Oakland City Planning Commission STAFF REPORT

Case File Number: REV100016 (PUD05335) **February 16, 2011**

Project Title:	**Revisions to Arcadia Park Residential Project**
Location:	**98th Avenue @ San Leandro Street (854 – 92nd Avenue; 860 – 92nd Avenue; and 999 – 98th Avenue) (see map on reverse)**
Assessor's Parcel Numbers:	Various (044-5078- and 044-5080-)
Proposal:	Modify access to a previously approved residential development (currently under construction), specifically restricting access to the site at "F" Street, "G" Street, and Ellington Way.
Applicant:	Arcadia Park Owners Association
Contact Person/Phone Number:	Arcadia Park Owners Association / (510) 830-7411
Owner:	Pulte Homes
Planning Permits Required:	Revision to a previously approved Planned Unit Development
General Plan:	Housing and Business Mix
Zoning:	R-30 One-Family Residential Zone (portion of site) and R-50 Medium Density Residential Zone (portion of site)
Environmental Determination:	An Environmental Impact Report (EIR) was prepared and certified for the residential project in 2005. No further environmental review is required for the proposed revisions.

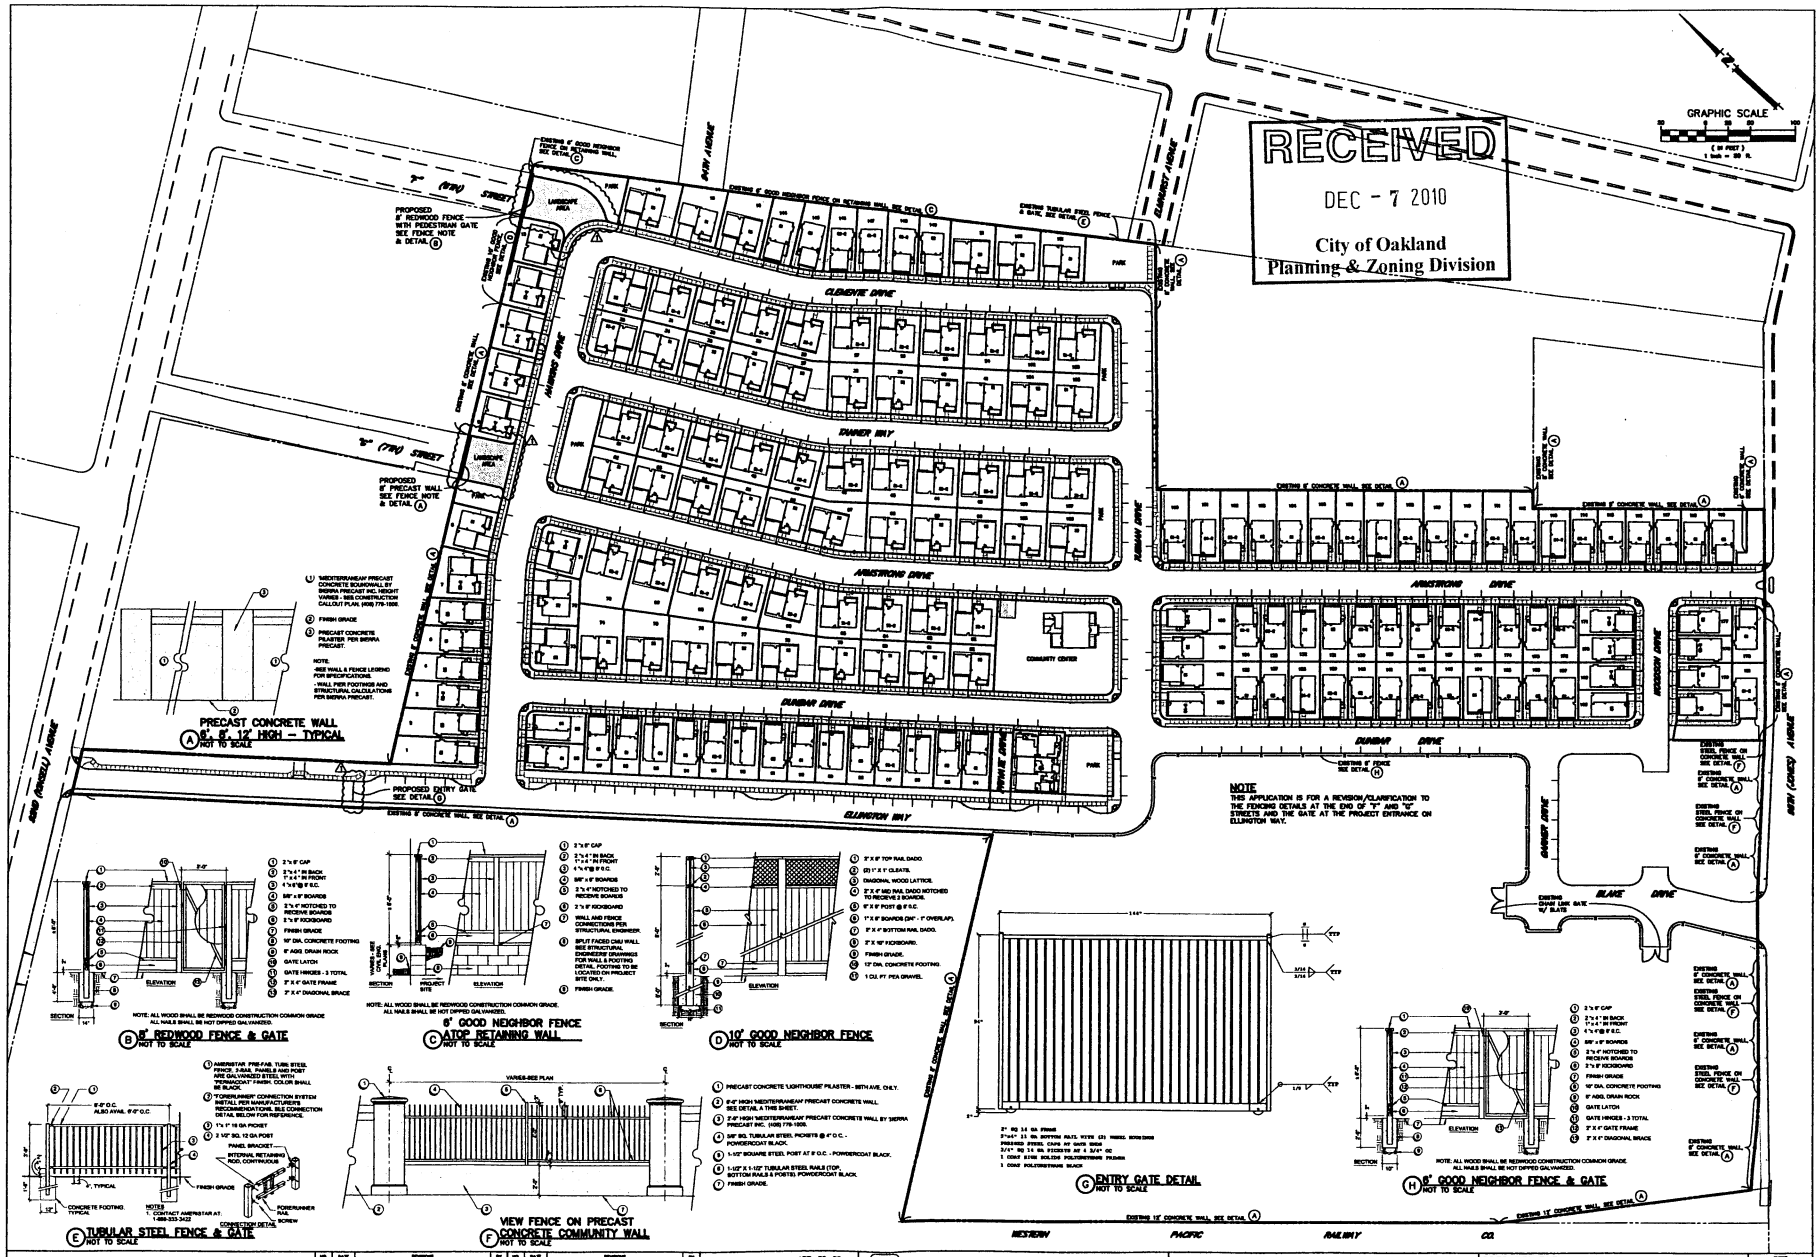
- "F" Street Closure: The applicant is proposing an eight-foot-tall wooden fence at "F" Street with a pedestrian gate. Staff believes it is appropriate to provide pedestrian access through this gate because the existing properties on "F" Street outside the project site contain residential uses that would benefit from having convenient access to the publicly-accessible parks and open spaces in the project. However, staff believes the fence and gate should be reduced in height to three and one-half feet to match the height of the proposed pedestrian gate at Elmhurst Avenue so that the gate is less visually intimidating and allows visibility through the gate to deter criminal activity on either side of the fence. An eight-foot-tall fence is unnecessary because, according to the Police Department, a determined criminal would be able to climb over an eight-foot-tall fence. Also, the fence should be constructed of more durable materials, like the steel fence proposed at Elmhurst Avenue, in order to withstand vandalism and general wear and tear.

- "G" Street Closure: The applicant is proposing an eight-foot-tall concrete wall at "G" Street (with no pedestrian gate). Staff believes it is not necessary to provide pedestrian access to "G" Street at this time because currently the existing properties on "G" Street outside the project site contain industrial uses where there would be little benefit of connectivity with the project site. However, it is possible that the industrial uses will convert to residential use at some point in the future. At that time, it would be appropriate to provide a lower fence and pedestrian gate similar to the recommended "F" Street fence and gate in order to increase connectivity between "G" Street and the project site. Staff recommends that the applicant be required to record a notice that would put the public, including Arcadia Park residents, on notice that the proposed eight-foot-tall wall may be removed at a future date. The concrete wall would be located in a public access easement that would give control of the wall to the City with the intent that the City could require a future developer of the "G" Street properties to replace the concrete wall with a lower fence and pedestrian gate.

- Ellington Way Gate: The applicant is proposing to install an automatic vehicle gate on Ellington Way within the project site that would be operable by project residents (and not the general

public). Ellington Way has been offered to the City as dedicated public right-of-way. Since the applicant would not be able to install a gate to restrict access on a public right-of-way, the offer of dedication would need to be rescinded by the applicant so that the "panhandle" portion of Ellington Way reverts to private use. Staff recommends that the gate meet the following requirements, subject to review and approval of the City:

1. The gate shall exhibit a high-degree of design and material quality.
2. The gate shall be accessible to the Oakland Fire Department, Oakland Police Department, and other emergency vehicles.

3. The gate shall restrict both vehicle access and pedestrian access.
4. At the gate there shall be a sign posted and visible from 92nd Avenue that identifies Ellington Way as a private entrance and that the public entrance to Arcadia Park is on 98th Avenue.

5. Except as noted above in item 2, the gate shall only allow vehicles and pedestrians to exit the site heading towards 92nd Avenue. The gate shall automatically open for all vehicles and manually for all pedestrians, including residents and the general public, exiting the site. The gate shall not operate for vehicles or pedestrians associated with the residents or the general public entering the site from 92nd Avenue. This element differs from staff's proposal in 2009 where staff proposed allowing residents to enter the site from Ellington Way as proposed by the applicant. Upon further consideration, staff now believes it is more equitable to restrict resident and general public movement in the same manner.

6. The gate shall be located near 92nd Avenue to prevent vehicles from needing to turnaround on Ellington Way at the gate if approaching the site from 92nd Avenue. There shall be sufficient queuing space between the gate and 92nd Avenue so that vehicles at the gate do not extend into the public right-of-way of 92nd Avenue.

7. Legal public access over the northern "panhandle" portion of Ellington Way must be removed so that the proposed gate is not restricting legal public access to the site. The applicant shall secure approval from the City of a mechanism, such as a real estate instrument, to rescind the offer of dedication of public right-of-way over this portion of Ellington Way, or take other legally appropriate actions, so that it remains private. The private portion of Ellington Way shall provide the same rights to the project residents and to the adjacent property to the northwest of the site (850 92nd Avenue; APN 044-4989-009-02) in the event that the adjacent property is redeveloped with residential lots that front onto Ellington Way. The beneficiaries of the private portion of Ellington Way shall be responsible for the operation, maintenance, repair, replacement, and/or reconstruction of the roadway and gate and provide for City review and approval an appropriate mechanism to ensure this obligation is met. The City shall not be responsible for the operation, maintenance, repair, replacement, and/or reconstruction of the roadway or gate.
